NRC [Letter 108 RAI \(Seismic Hazards\) Dated March 15, 2012](#)

[Progress Energy Response L-0998 to NRC RAI:](#)

Levy Nuclear Plant Units 1 and 2
COL Application
Part 2, Final Safety Analysis Report

Revised Figure 2.5.2-296: Horizontal and Vertical Scaled GMRS for the LNP Site.

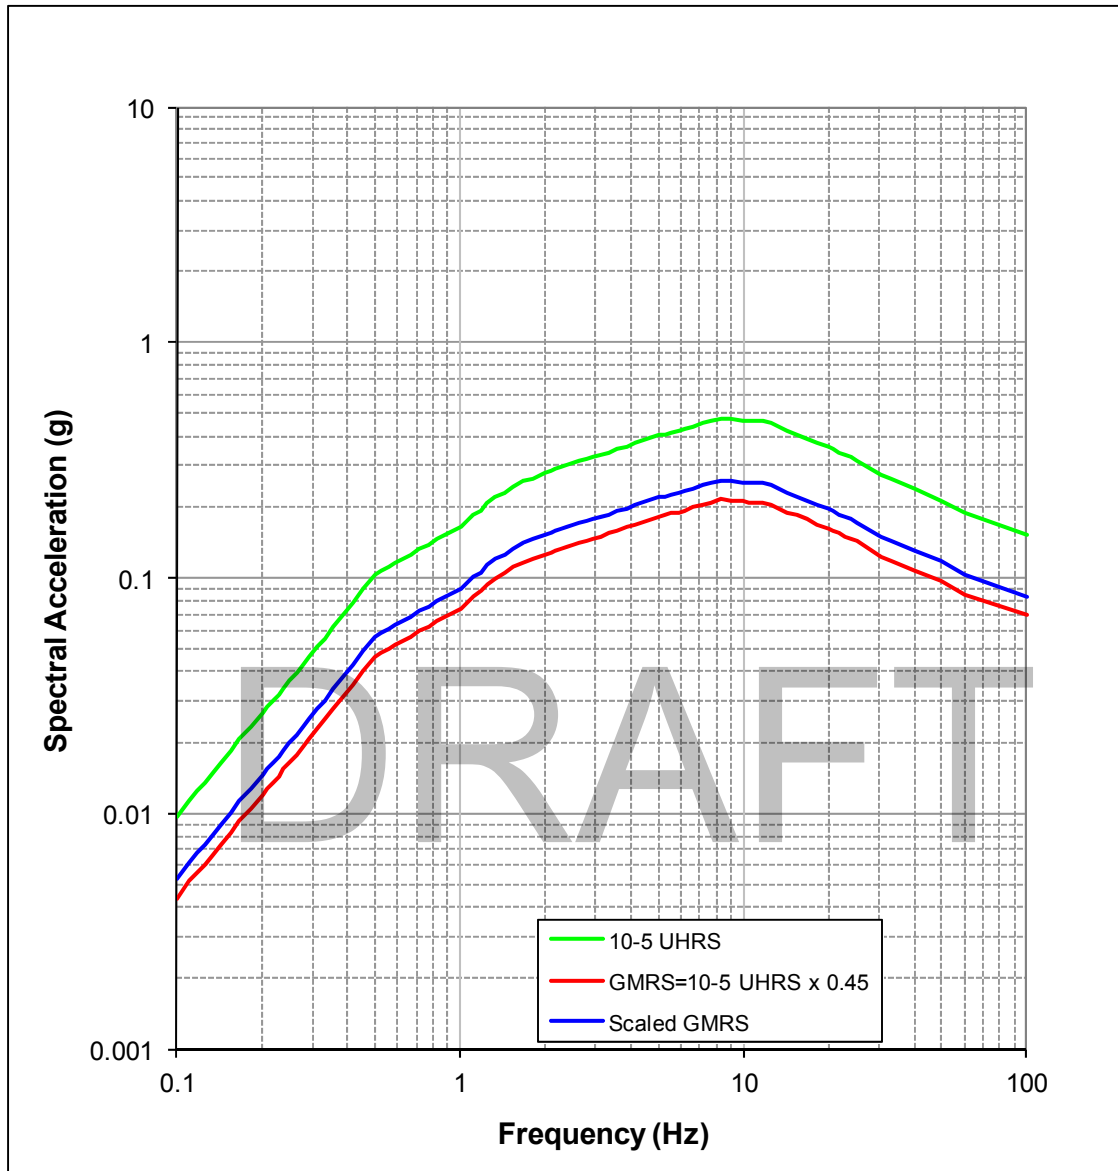
Evaluate the seismic hazard at your site against current NRC requirements and guidance and, if necessary, update the design basis and structures systems and components important to safety to protect against updated hazards (seismic portion only – of detailed Recommendation 2.1 – Enclosure 7 of SECY-12-0025).

The scaled horizontal and vertical GMRS are compared to the Westinghouse Certified Seismic Design Response Spectra (CSDRS) on Figure 2.5.2-296. The site scaled GMRS are enveloped by the CSDRS.

The [scaled](#) horizontal and vertical GMRS are compared to the Westinghouse Certified Seismic Design Response Spectra (CSDRS) on [Figure 2.5.2-296](#). The site [scaled](#) GMRS are enveloped by the CSDRS.
